MEMORANDUM

SUBJECT: Idaho Pacific Wastewater Reuse Permit Application Review -- LA-000030-03
(Industrial Wastewater Facility)

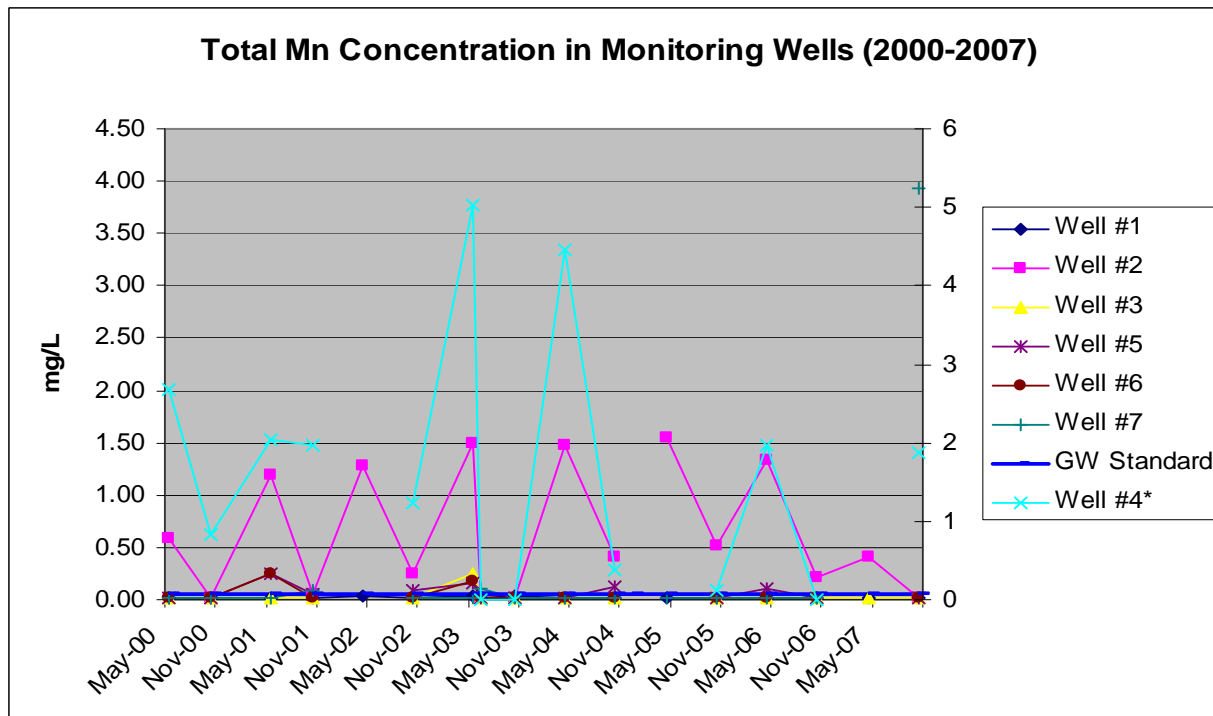
* Due to the extremity of Well #4's total Fe levels as compared with the other wells, it has been plotted on a secondary axis.

As evidenced by the graphs above, the facility has shown elevated levels of total iron (Fe) and manganese (Mn) in down-gradient wells on a number of occasions. The Ground Water Quality Rule (IDAPA 58.01.11) gives the secondary constituent standards for iron and manganese as 0.3 milligrams per liter (mg/L) and 0.05 mg/L, respectively. Many samplings have exceeded these standards by a fairly significant amount, with results in several of the wells ranging from 1.00 mg/L to as high as 2.00 mg/L and above for both constituents; in Well #4 the results have been as high as 5.0 mg/L for Mn and 29.7 mg/L for Fe. The facility attributes these elevated concentrations to high turbidity levels in the wells.

Following the high results of the May 2003 sampling the facility re-sampled all of the wells in June, testing for both total and dissolved iron and manganese. While the results for total Fe and Mn in June 2003 were in general lower than the May 2003 sampling and the dissolved results were lower still, one sampling can be considered neither representative nor conclusive. See Table 1 below for a comparison of the total and dissolved results from this sampling event.

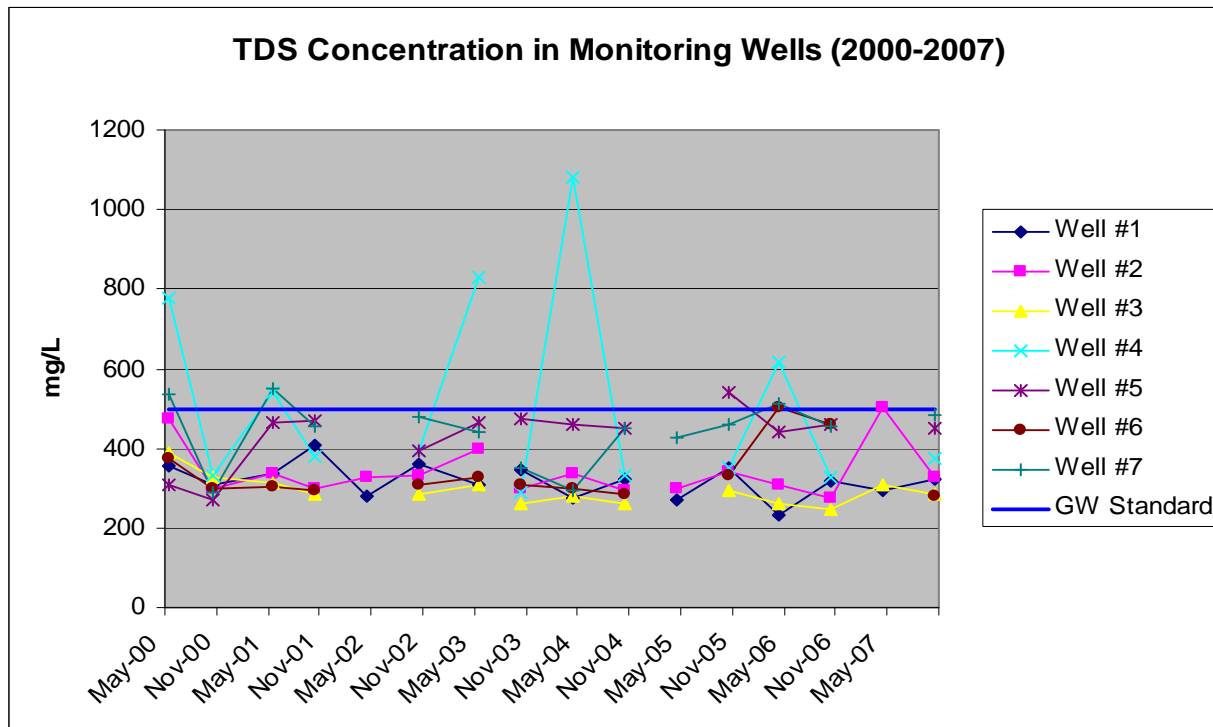
* Due to the extremity of Well #4's total Mn levels as compared with the other wells, it has been plotted on a secondary axis.

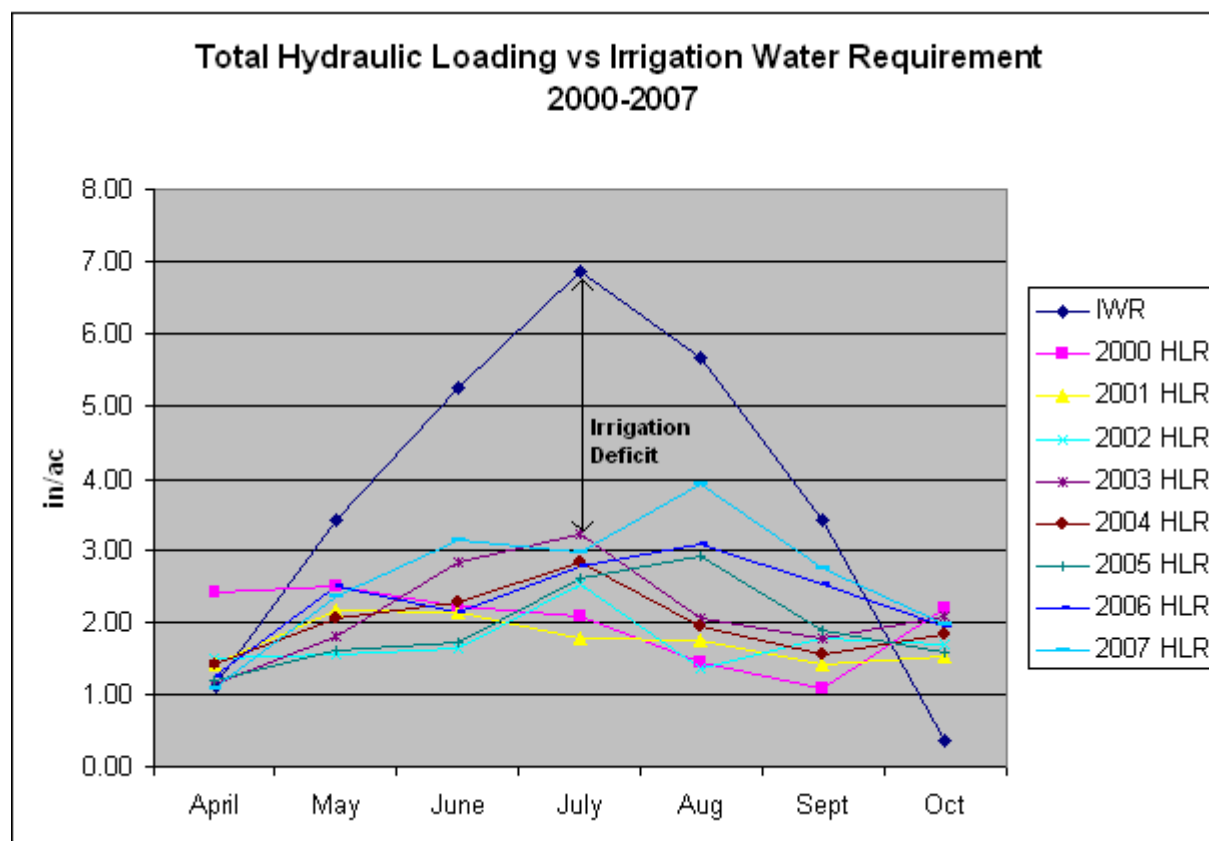
While permit LA-00030-02 required the facility to meet a nitrogen loading limit of 150% of typical crop uptake on all management units by September 1, 1999, this goal has never been achieved, even with the year-long DEQ-granted extension. As a result, this site has been consistently overloaded by an average of 145 pounds per acre (lbs/ac-yr) for the past six years. The facility's treatment processes and generation rates have remained relatively constant during the course of the permit term, with aforementioned exception of the reduction in flow caused by the January 2000 scrubber replacement; however, the nitrogen, COD, and TDS concentrations of the wastewater appear to have been decreasing rather precipitously since the spring of 2004. For an illustration of this trend, see the graph below.
